**Response to Public Comments on  
Draft Title V Air Operating Permit  
&  
Draft Non-Title V Air Operating Permit**

**Stimson Lumber Company; Permits R10T5020200 and  
R10NT501001**

**July 1, 2021**

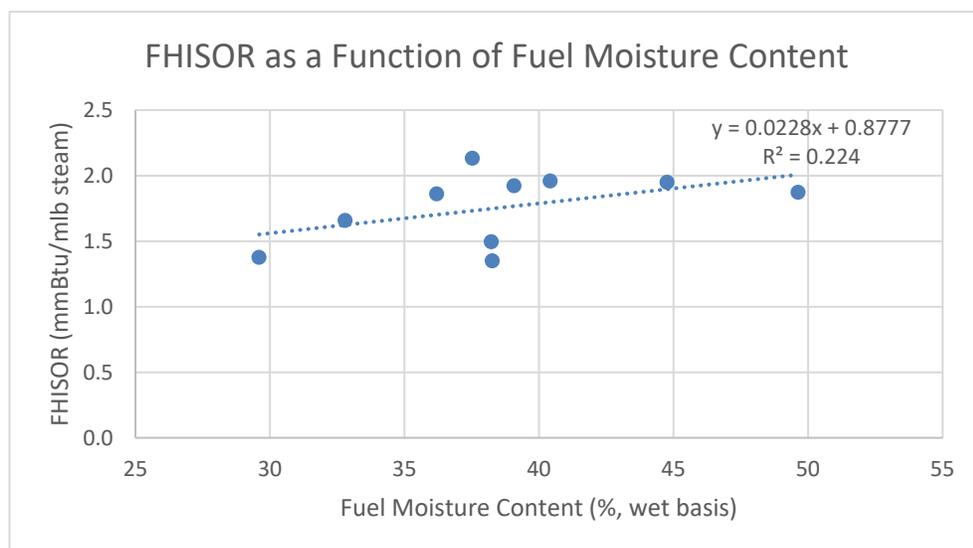
Stimson is suggesting a simple solution in the non-Title V permit: simply remove the reference to the mandated Title V tests and replace with a reference to "approved compliance tests." This will also address the incorporation of additional voluntary tests as they would need prior approval of the source test protocol by EPA. We address the direct issue of the timing of the mandated tests in our comments on the Title V.

- (1) Determine one time of the year considered to be "average." Stimson suggests the Fall
- (2) Alternate source tests between summer and winter. This is conceptual attractive but given that there may be years between tests could be cumbersome and may not actually solve the issue.
- (3) Test twice during the years when testing is required. This does generally solve the issues but requires twice the amount of testing, so we are unsure at this point how supportive we could be.
- (4) Stimson propose a sampling plan for EPA approval that details one of these approaches or proposes another. d propose an alternative.

**Response: R10 is not making any changes to the pre-draft non-Title V permit or TSD in response to this comment. Test results from October 2012, 2014 and 2018 do not illustrate a strong correlation between FHISOR and fuel moisture content. The following chart is in the administrative record for this permitting action.**

**If the two rounds of testing required by the non-Title V permit illustrates a strong correlation between FHISOR and fuel moisture content, or between FHISOR and some other environmental factor(s) (e.g., ambient temperature), then Stimson can request a revision to the non-Title V permit to provide the opportunity to conduct one summer-time FHISOR test for each winter-time RM5 PM/FHISOR test in order to counter-balance the test results. Alternatively, Stimson and R10 could consider revising the permit to create season-specific FHISOR. There is currently insufficient information on the degree to which environmental conditions influence FHISOR (if at all) to justify including permit conditions to address the issue.**
